# Work Order ID 63063

Item Name: Basket Hoop

DESIGN #	DRAWN BY CP	DART AEROSPACE LTD HAWKESBURY, ONTARIO, CANADA	
CHECKED #	APPROVED #	DRAWING NO. D3166	REV. A SHEET 1 OF 1
DATE 02.07.10		TITLE BASKET HOOP	SCALE NTS
A	02.07.10	NEW ISSUE	
A1	04.04.08	38+/-1 WAS 36.0

DRAWING NO. D3166	TITLE BASKET HOOP	REV A1	<b>DART AEROSPACE LTD ENGINEERING ORDER</b>		D.E.O. NO. D3166-A-2	SHEET NO. 1 OF 1	SCALE NTS
DRAWN AJS	CHECKED <i>[Signature]</i>	MFG. APPR. <i>[Signature]</i>	APPROVED <i>[Signature]</i>		DE APPR. <i>[Signature]</i>		
DATE 08.12.11	DATE 08.12.15	DATE 08/12/15	DATE 08/12/16		DATE 08.12.16

D3166-1 BASKET HOOP

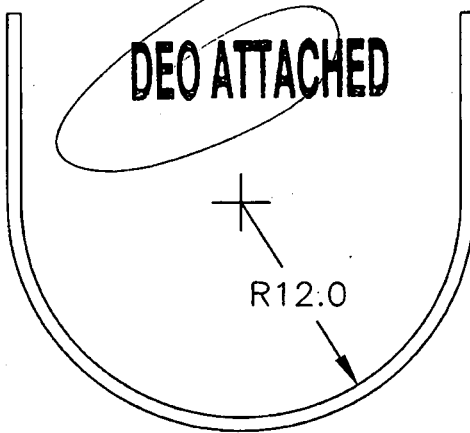
1) MODIFY MATERIAL NOTE FOR D3166-1 AS SHOWN:

WAS:

- 1) MATERIAL: AISI 304/316 SS SQUARE TUBING,  
0.75" x 0.75" x 0.063 WALL, 60.00" LONG  
(REF DART SPEC. M304TS0.750W.063)

IS:

- 1) MATERIAL: AISI 304/316 SS, 3/4 X 3/4 X 0.065 WALL SQUARE TUBING,  
60.00" LONG  
REF. DART SPEC M304TS0.750W.065

D3166-3 BASKET HOOP

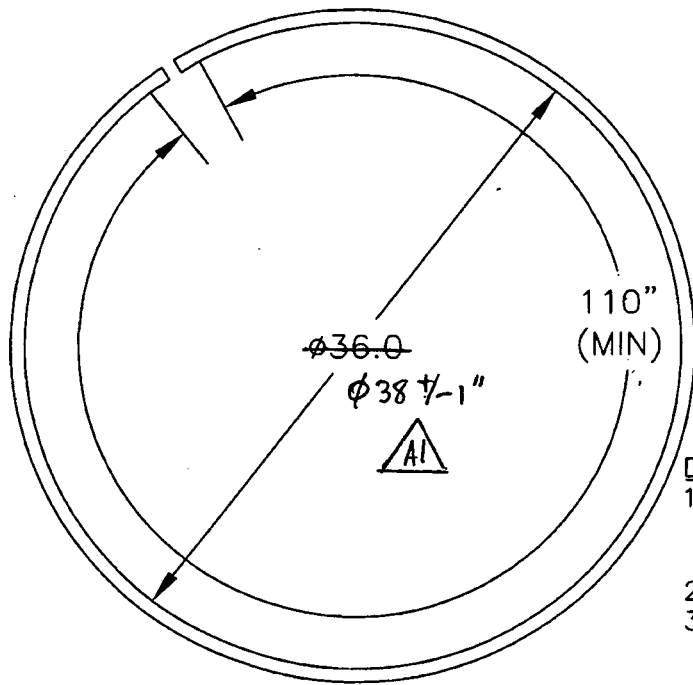
2) MODIFY MATERIAL NOTE FOR D3166-3 AS SHOWN:

WAS:

- 1) MATERIAL: AISI 304/316 SS SQUARE TUBING,  
0.75" x 0.75" x 0.063 WALL, 120.00" LONG  
(REF DART SPEC. M304TS0.750W.063)

IS:

- 1) MATERIAL: AISI 304/316 SS, 3/4 X 3/4 X 0.065 WALL SQUARE TUBING,  
120.00" LONG  
REF. DART SPEC M304TS0.750W.065
